Product Change Notification

PCN-MI-5572-2020

Description for Product Change Notification

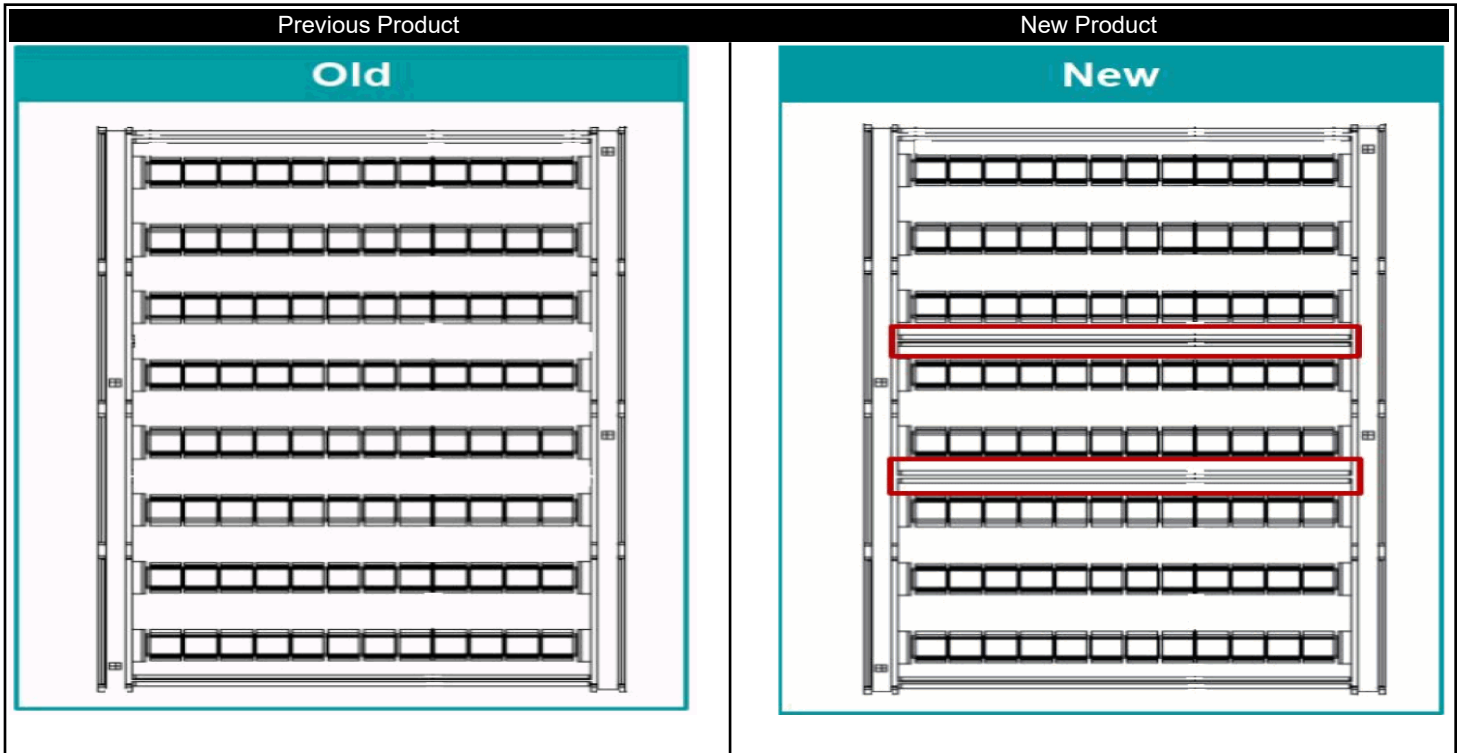
Addition of reinforcement rails for UC-TMF...This keeps the marking sheet from bowing during the printing process in the BLUEMARK ID, and thus eliminating possible misprints.
